HOLTEC INTERNATIONAL
HI-STORM 100 CASK SYSTEM
SAFETY EVALUATION REPORT

Figure 4.1 The effect of thickness reduction due to oxidation of the PWR cladding on the stress.

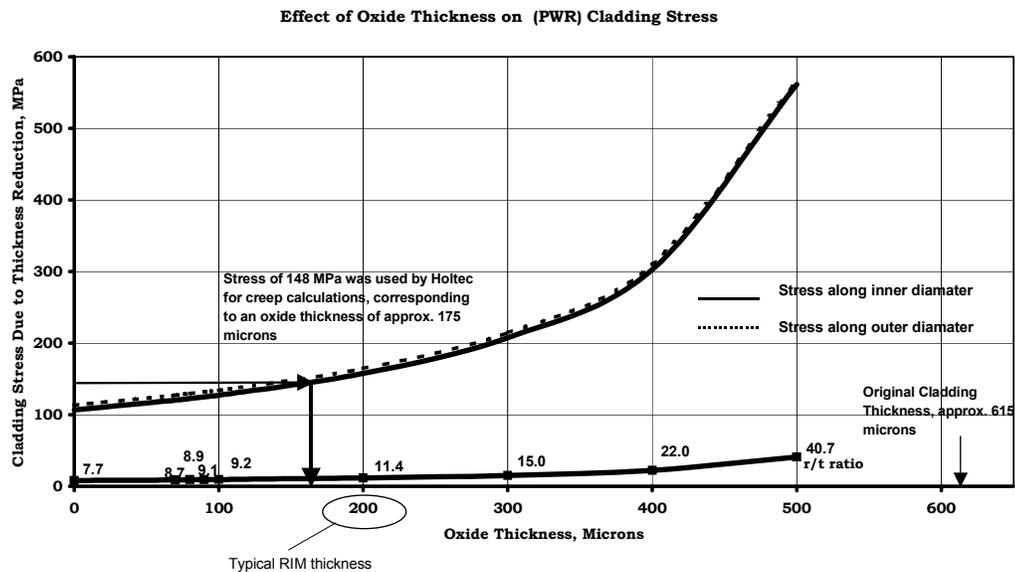
For the PWR fuel cladding, for an internal pressure of 2,000 psi at the start of storage, a radius to thickness ratio of 10.5 was used to determine the cladding stress of 144.7 MPa. Staff has

determined that this value corresponds to an oxide thickness of approximately 175 microns, as shown in Figure 4.1.

Thus, by eliminating the oxide outer layer, the applicant uses a higher stress value for the cladding, as if approximately 175 microns of oxide layer has been removed from the total metal thickness. Considering that the experimentally verified (Figure 4.A.13 in Appendix 4-A of the Holtec SAR) cladding oxide thickness varies between 100 to 140 microns at a burnup of 60 GWd/MTU, the staff has concluded that the applicant's approach has included reasonable conservatism in its analyses.

Figure 4.2 The effect of thickness reduction due to oxidation of the BWR cladding on the stress.

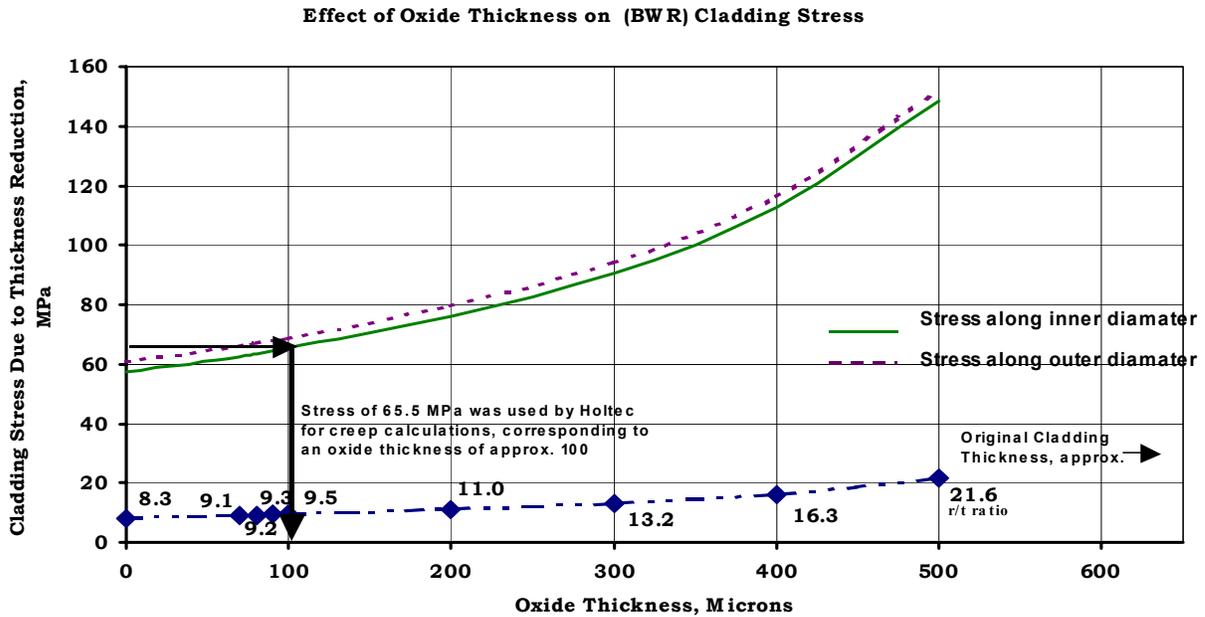
For the BWR fuel cladding, for an internal pressure of 1,000 psi at the start of storage, a radius to thickness ratio of 9.5 was used to determine the cladding stress of 65.5 MPa. Staff has determined that this value corresponds to an oxide thickness of approximately 80 microns, as shown in Figure 4.2. Thus, by eliminating the oxide outer layer, the applicant uses a higher stress value for the cladding, as if approximately 80 microns of oxide layer has been removed from the total metal thickness. Experimental data have not been provided for cladding oxide thickness as a function of burnup for the BWR fuel cladding. However, considering the less severe potential for oxidation in BWR, when compared to PWR, the staff has concluded that the applicant's approach has included reasonable conservatism in its analyses.
